REVISED RESPONSE TO REQUEST FOR ADDITIONAL INFORMATION

APR1400 Design Certification

Docket No. 52-046

RAI No.: 182-8160
SRP Section: 03.07.01 – Seismic Design Parameters
Application Section: 3.7.1
Date of RAI Issue: 08/31/2015

Figure 3.7-23 Generic Soil Profiles Proposed for APR1400 Standard Design

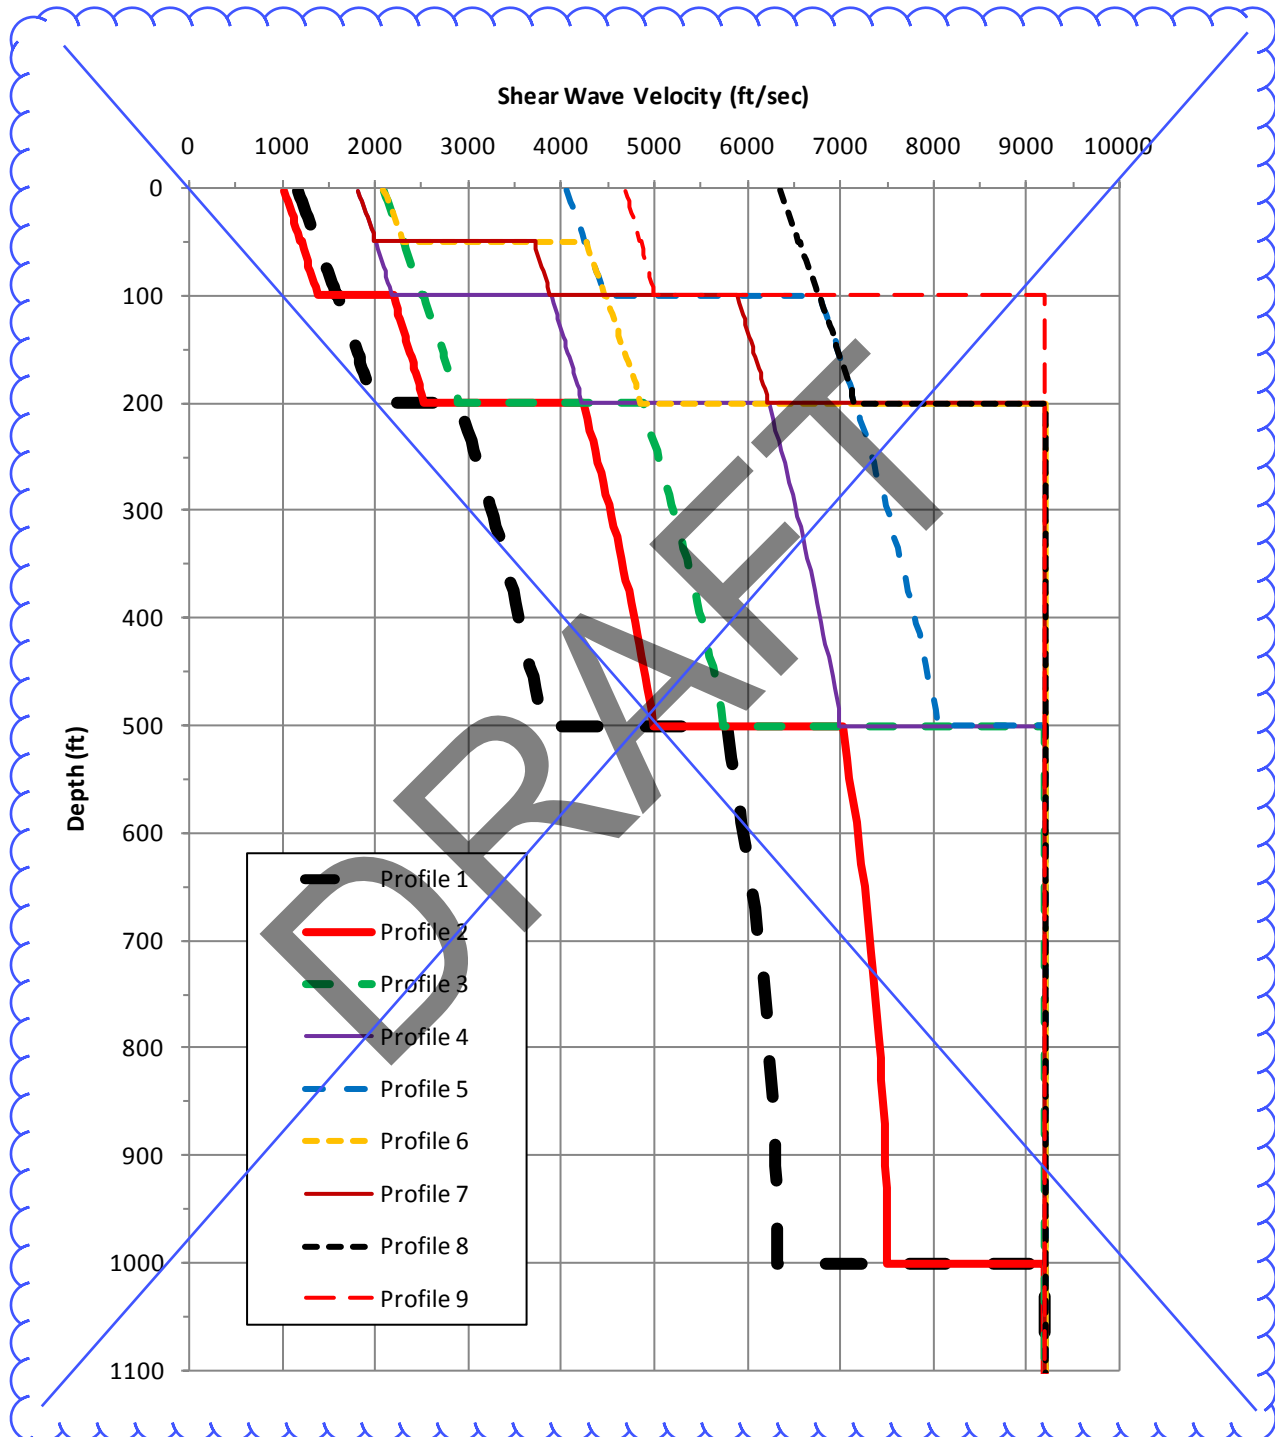
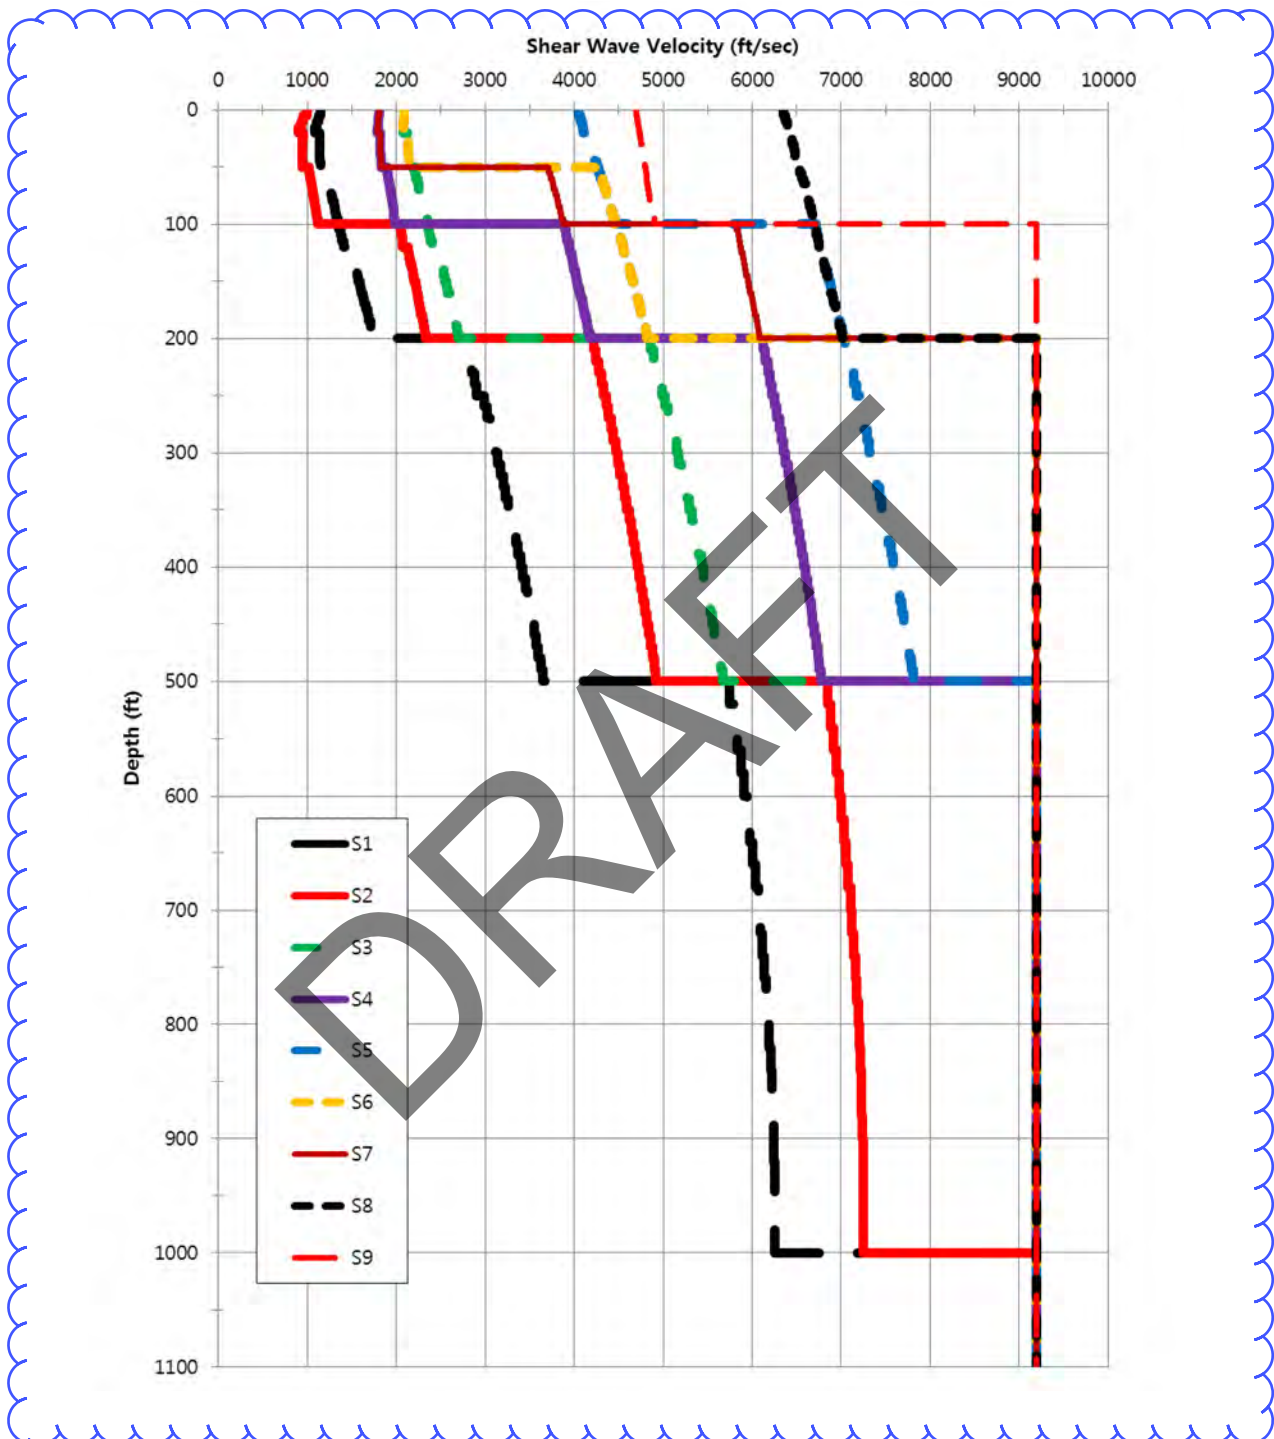
DCD Tier 2, Table 1.8-2, Subsections [2.5.2.6](#), [2.5.6](#), [3.7.1.2](#), [3.7.1.3](#), ~~and 3.7.5~~, [3.7.6](#), [Figure 3.7-23](#), [Appendices 3.7A and 3.7B](#) will be revised, as indicated in the attachment associated with this response.

Replace with Figure in next page.

Figure 3.7A-1 Shear Modulus with Shear Strain

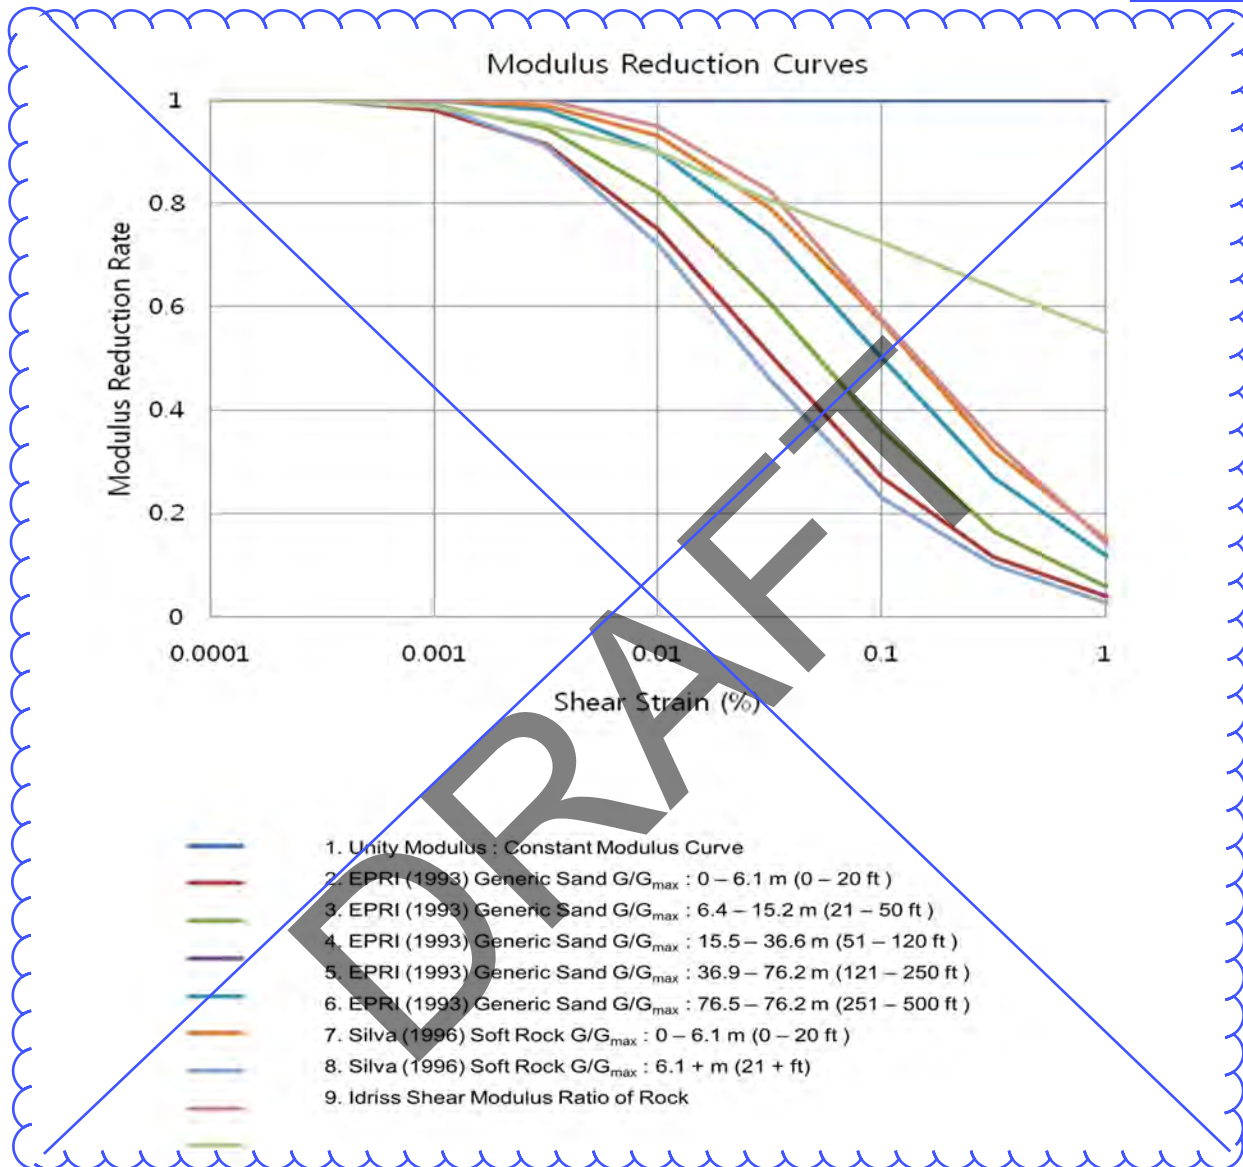
Deleted

Figure 3.7A-6 Shear and Compression Wave Velocity Profiles for S4

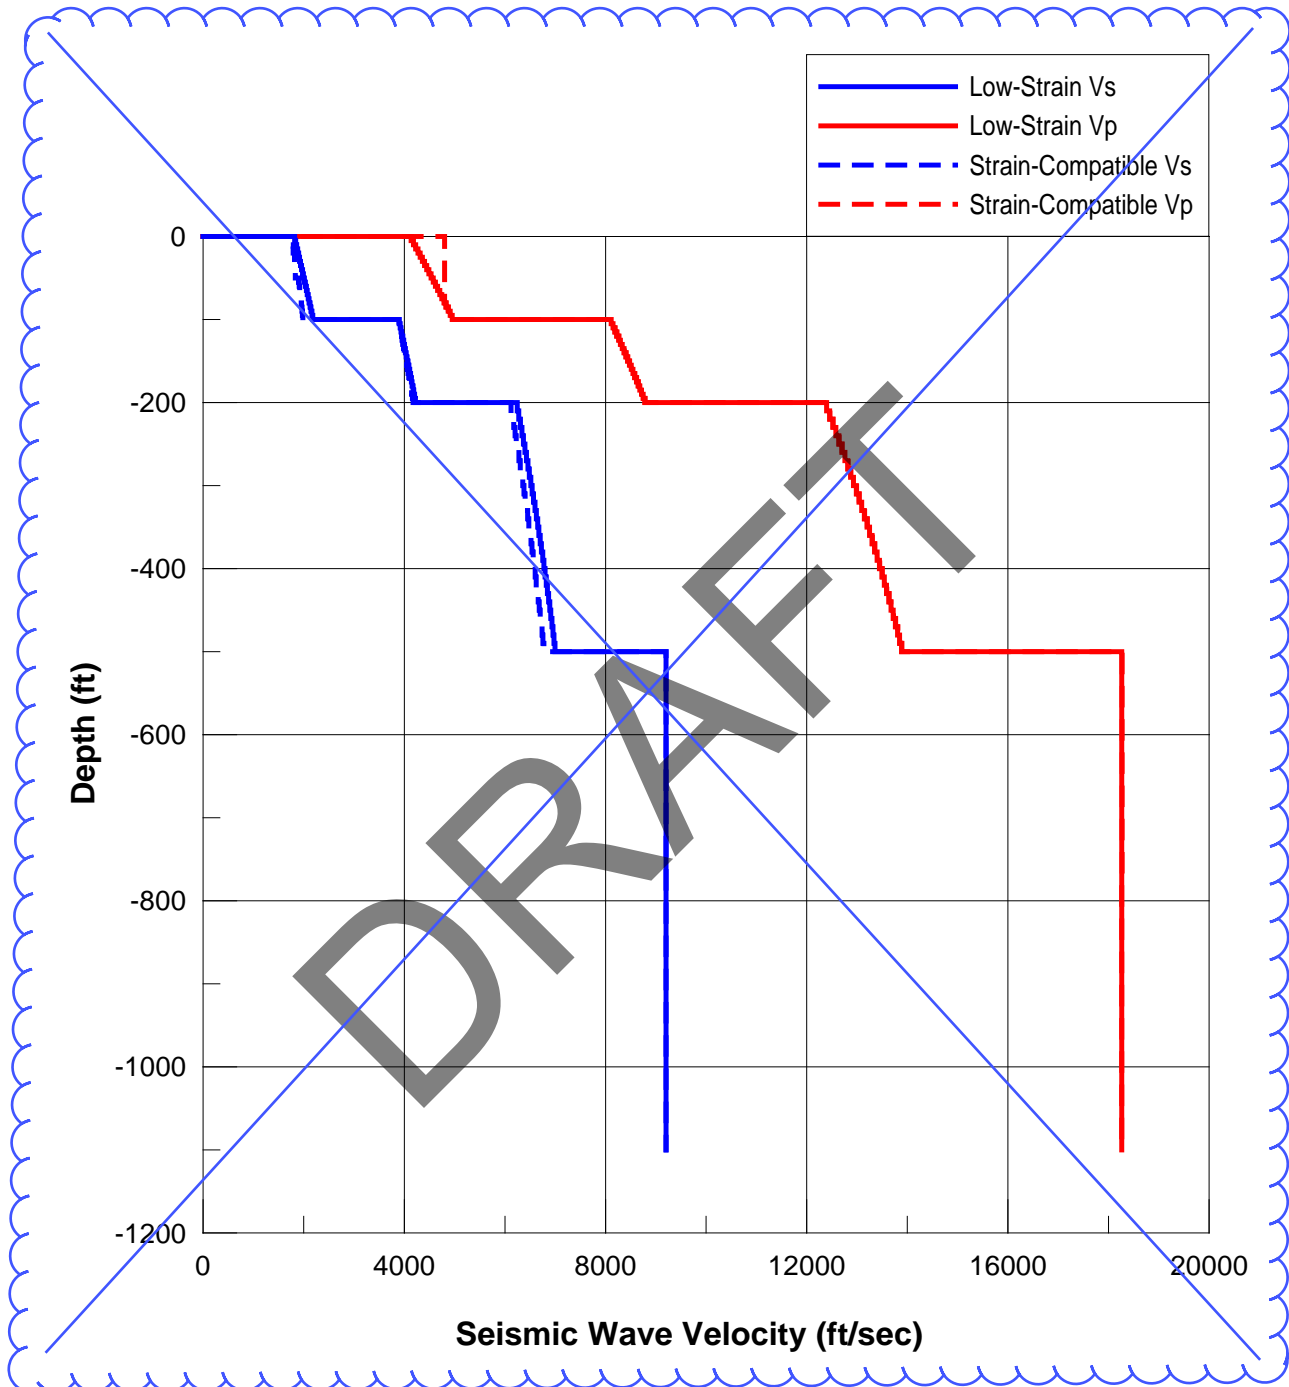
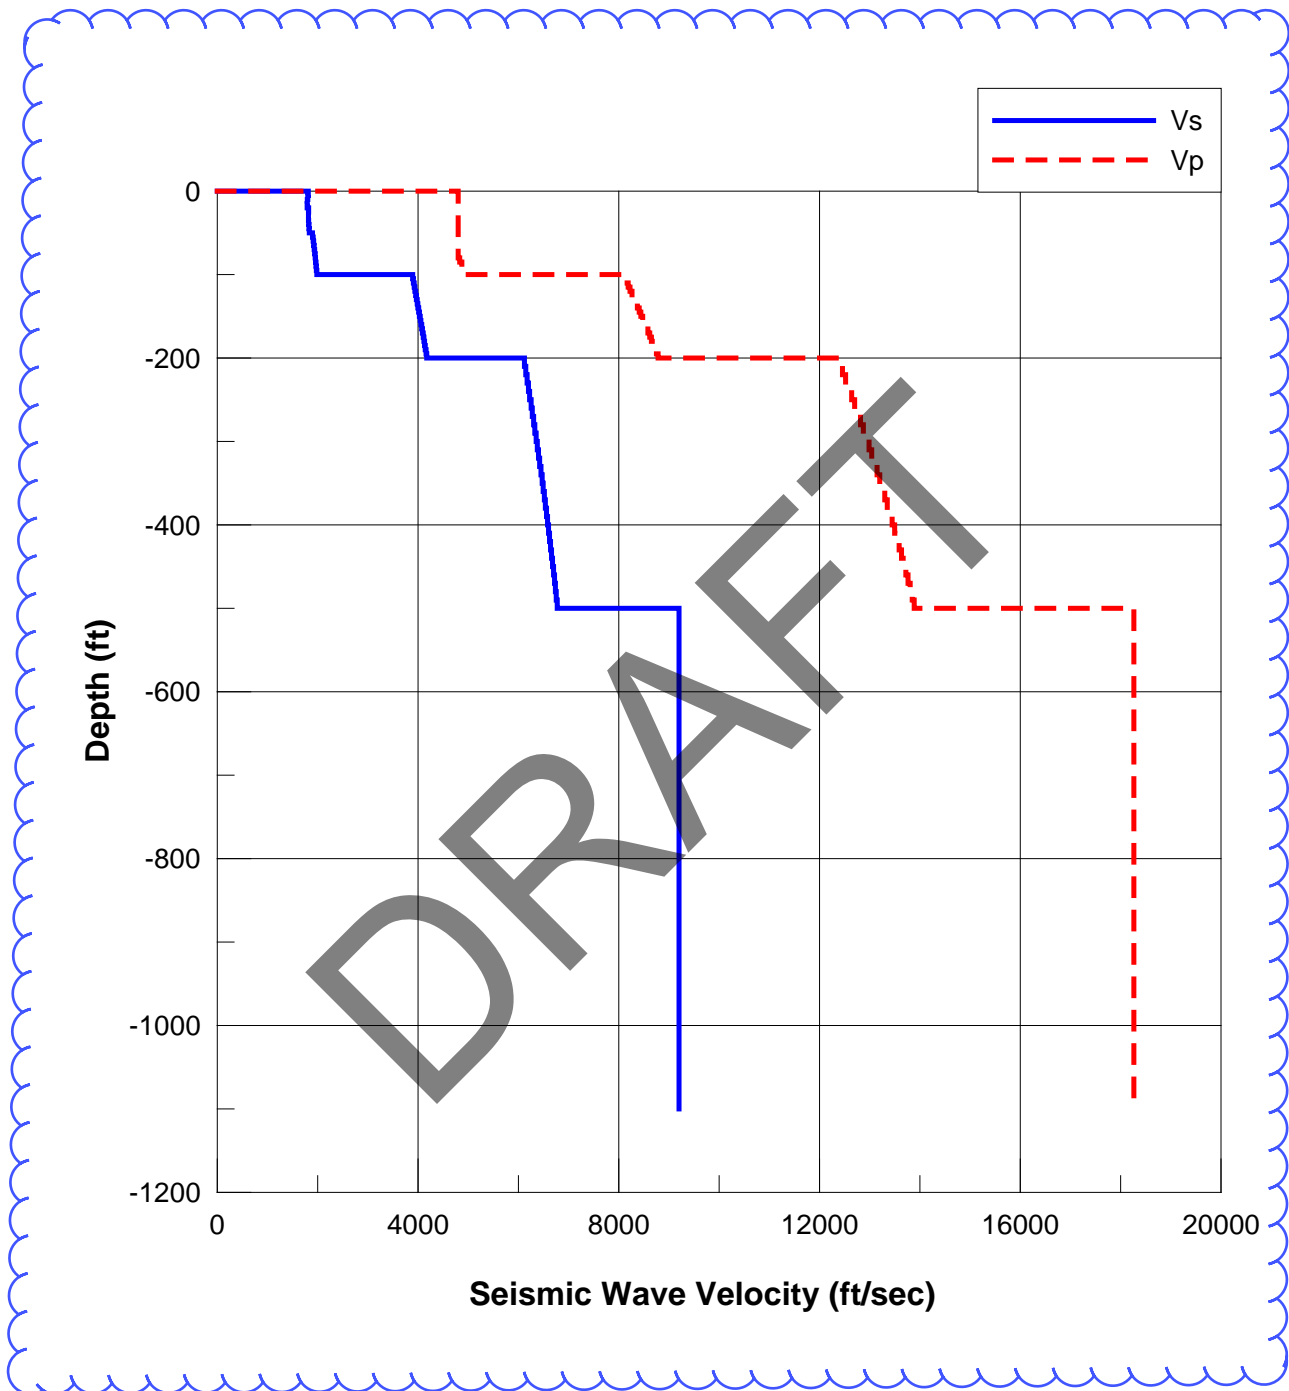
Replace with Figure in next page.
